APPLICANT: Prime Senior Living Group, LLC	PETITION NO.: <u>Z-10</u>
PRESENT ZONING: R-80	PETITION FOR: RSL (Supportive)
* * * * * * * * * * * * * * * * * * * *	* * * * * * * * * * * * * * * * * * * *
ZONING COMMENTS: Staff Member Respon	sible: Jason A. Campbell
Land Use Plan Recommendation: Low Density Reside	ential (1-2.5 units per acre)
Proposed Number of Units: 138 Over	rall Density: 18.9 Units/Acre
Staff estimate for allowable # of units: <u>3</u> Units* *Estimate could be higher or lower based on engineered plans taking	Increase of: <u>135</u> Units/Lots into account topography, shape of property, utilities, roadway

Z-10 PRIME SENIOR LIVING GROUP, LLC

Z-10-2017 GIS

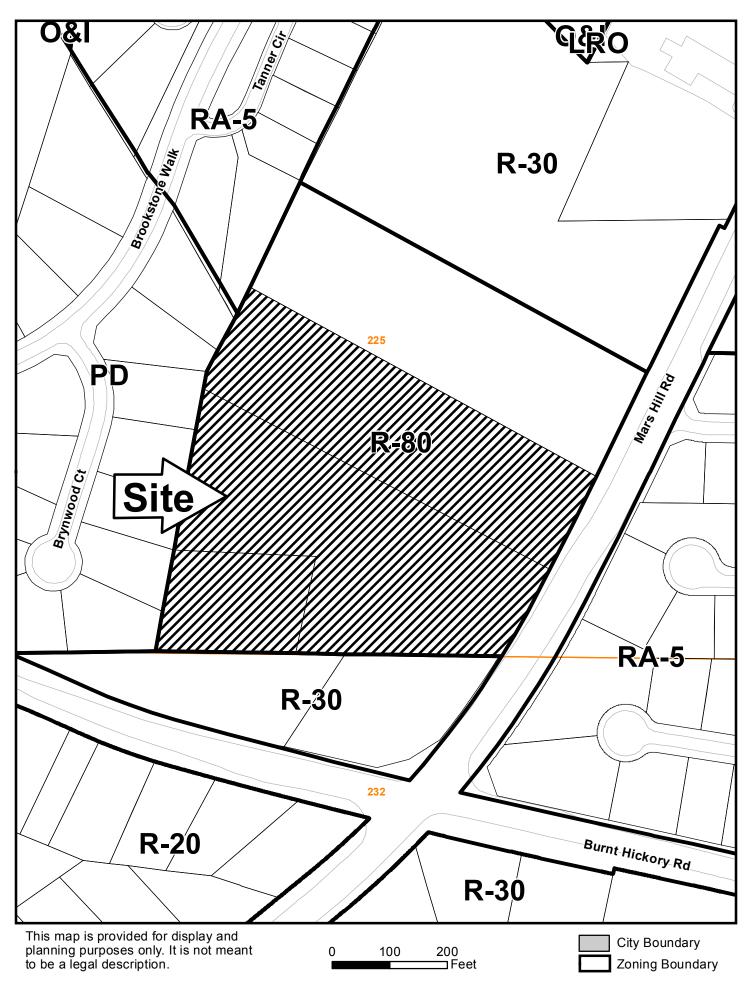
- A. It is Staff's opinion that the applicant's rezoning proposal will not permit a use that is suitable in view of the use and development of adjacent and nearby properties. The subject property abuts R-80, PD and R-30 for single-family houses on individual lots.

- B. It is Staff's opinion that the applicant's rezoning proposal will have an adverse effect on the usability of adjacent or nearby property. The proposed use is more intense than what exists on abutting properties. The zoning and land use categories increase north of the subject property approaching the intersection of Mars Hill Road, Stilesboro Road and Brookstone Drive.

- D. It is Staff's opinion that the applicant's rezoning proposal is not in conformity with the policy and intent of the *Cobb County Comprehensive Plan*, which delineates this property as being in the Low Density Residential (LDR) land use category for densities ranging from 1-2.5 units per acre. The requested RSL (supportive) zoning category is designed to be located on properties designated as Regional Activity Center (RAC), Community Activity Center (CAC), and Neighborhood Activity Center (NAC) on the *Cobb County Comprehensive Plan*. Other properties in the area include: Burnt Hickory Lakes Phase 1 (zoned R-30 at 1.19 units per acre); Brookstone PD1 (zoned PD at approximately 2.03 units per acre); Hickory Plantation (zoned RA-5 at approximately 2.45 units per acre); and Brookstone Commons (zoned RA-5 at 2.87 units per acre). The proposed density is 18.9 units per acre.

- E. It is Staff's opinion that there are existing and changing conditions affecting the use and development of the property which give supporting grounds for denying the applicant's rezoning proposal. Staff feels applicant's request is not compatible with the surrounding properties that consist of single-family houses on individual lots, nor is it compatible with the *Cobb County Comprehensive Plan* designation of Low Density Residential (LDR). RSL (supportive) is designed to be located within properties delineated as being in the Regional Activity Center (RAC), Community Activity Center (CAC) and Neighborhood Activity Center (NAC) land use categories. The RSL (supportive) category is also designed to function as a cut-off for non-residential uses *within* an activity center and a transitional use to residential uses adjoining activity centers. The subject property is in the LDR land use category and does not adjoin an activity center such as RAC, CAC and NAC.

Based on the above analysis, Staff recommends DENIAL.
